## PRODUCT/PROCESS CHANGE NOTIFICATION

PCN APG-PTS/14/8573

**L9958 Family : Activation of Catania 8" Wafer Fab and  
Copper Wire Conversion (Au 3mils to Cu 2.5mils)**

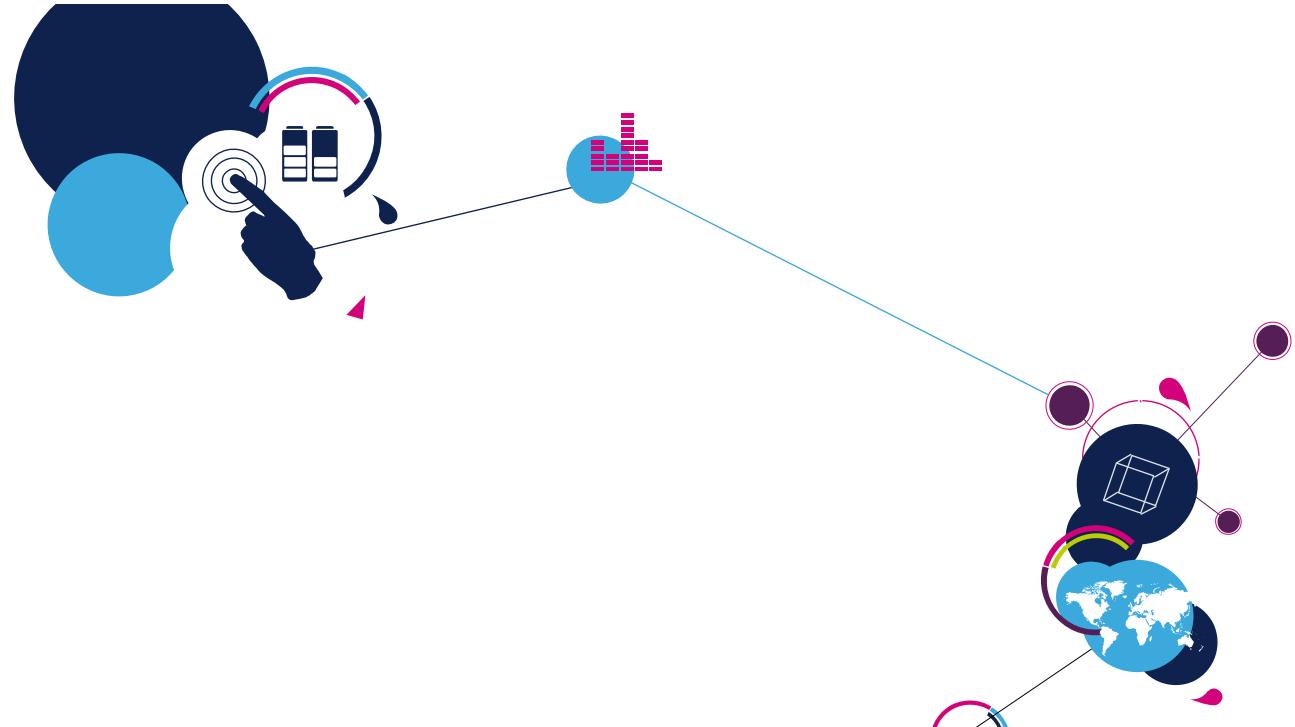
Change will be implemented according the following schedule:

Availability of samples: End of July 2014

Qualification results: Mid of September 2014

Implementation date for change: End of September 2014
